Flight Procedures Cover Page	Task Action: Abbreviated Amendment	Task Type: IAP	Estimated Chart Date: 06/12/2025	APWS Task ID: 6AA495A88F48497AB5360A01FD63FAF3	APWS Project ID: 74E9433C10034F9B9C941BD2B4C492B7
Procedure: RNAV (GPS) RWY 32 AMDT 0E		Enroute: NO	Specialist: Johnson, Raymond		Agreement Number:
Airport ID: KSSF			Airport City: SAN ANTONIO		State: TX
Facility ID:	Facility Type:	Flight Inspection Remark Type:			
<div>Procedure Comments: Concurrent with VOR RWY 32 AMENDMENT 14D DUE TO SSF VORTAC MAGVAR AND KSSF AIRPORT MAGVAR UPDATED</div> <div>LOA (1) VDA VERTICAL DESCENT ANGLE</div> <div>WAIVER (1) OFFSET 0.00 FEET FROM LTP.</div> <div>CONTACT: ALLAN WILL, AJV-A423, 405-954-6103.</div> <div><div>QUALITY 41 CHECKED</div><div>QUALITY 29 CHECKED</div></div>

RNAV (GPS) RWY 32
STINSON MUNI (SSF)

Subject: Approval Request: STINSON MUNI, RNAV (GPS) RWY 32

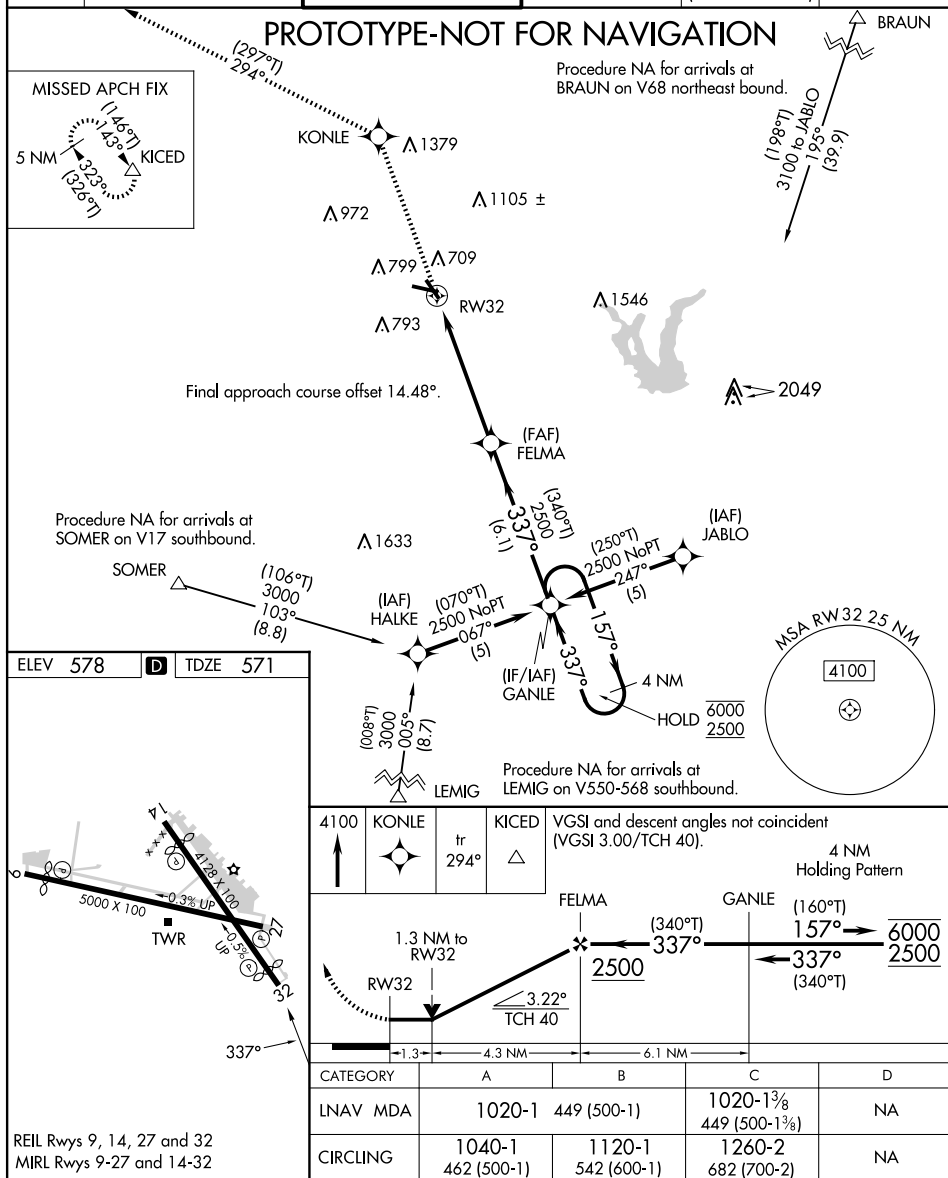
Request approval for 3.23° Vertical Descent Angle (VPA) for RWY 32. The difference between VDA and Visual Glide Slope Indicator (VGSI) angle exceeds 0.2°. FAA Order 8260.3G Paragraph 2-6-2 (a) states “approval is required to establish a GPA or VDA (of a procedure where the FAC is straight-in aligned) that is more that 0.2° greater than the glide path angle of a VGSI installed on the same runway”.

REQUEST TO NOT CROSS RUNWAY CENTERLINE EXTENDED AT LEAST 3000 FEET PRIOR TO LTP (5200 FEET MAXIMUM). APPLICABLE STANDARD FAAO 8260.58C 3-2-2A(3): Offset > 10 degrees and = 20 degrees. The course must cross the runway centerline extended at least 3000 feet prior to LTP (5200 feet maximum).

The final approach course, offset by 14.483342086168534 degrees, intersects the runway centerline extended at 0.0 ft from the LTP. For Non-vertically guided finals, it must intersect in the area at or within 3000.0 ft and 5200.0 ft from the LTP

The purpose of this procedure amendment is to update the Magnetic Variation of KSSF. On the original design of this procedure, the higher VDA was for obstacle avoidance and to provide relief to Historic Parks in the area. The next full amendment of this procedure is scheduled for 10/2/2025 where flight paths are proposed to change. A redesign will take place and a new environment review will be conducted to determine the necessity of a VDA that is higher than the VGSI. If approval is not granted, the VDA would have to be addressed which might result delay the project.

FINAL OFFSET TO AVOID NATIONAL HISTORICAL PARK.

The purpose of this procedure amendment is to update the Magnetic Variation of KSSF. On the original design of this procedure, the offset was for obstacle avoidance and to provide relief to Historic Parks in the area. The next full amendment of this procedure is scheduled for 10/2/2025 where flight paths are proposed to change. A redesign will take place and a new environment review will be conducted to determine the necessity of an offset at 0.0 feet from the LTP. If approval is not granted, the VDA would have to be addressed which might result delay the project
